December 22, 2011 Subject: **Apache 360 Mounting Kit Update**

No. **2012-3**

ACCESSORY	MODEL NUMBER	SERIAL NUMBER
Apache 360 Mounting Kit	715 000 937	All

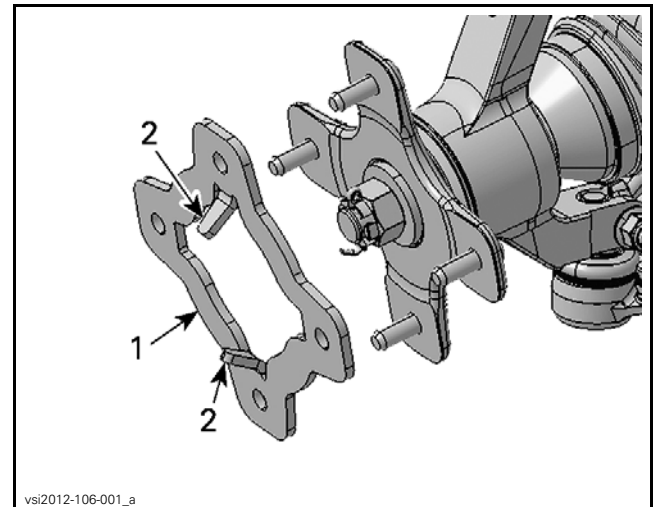
On a limited quantity of the above described accessory, the front tracks may rub against the ball joint of the steering tie-rod ends, and damage them.

An update kit has been created; it includes 2 spacers.

The information about track spacers installation is provided in the new instruction sheet provided with the *FRONT SPACERS KIT* (P/N 715 001 700), (refer to page 6 of instruction sheet).

1. Track spacer
2. Tabs outside

Always remove front track spacers when re-installing wheels on vehicles.
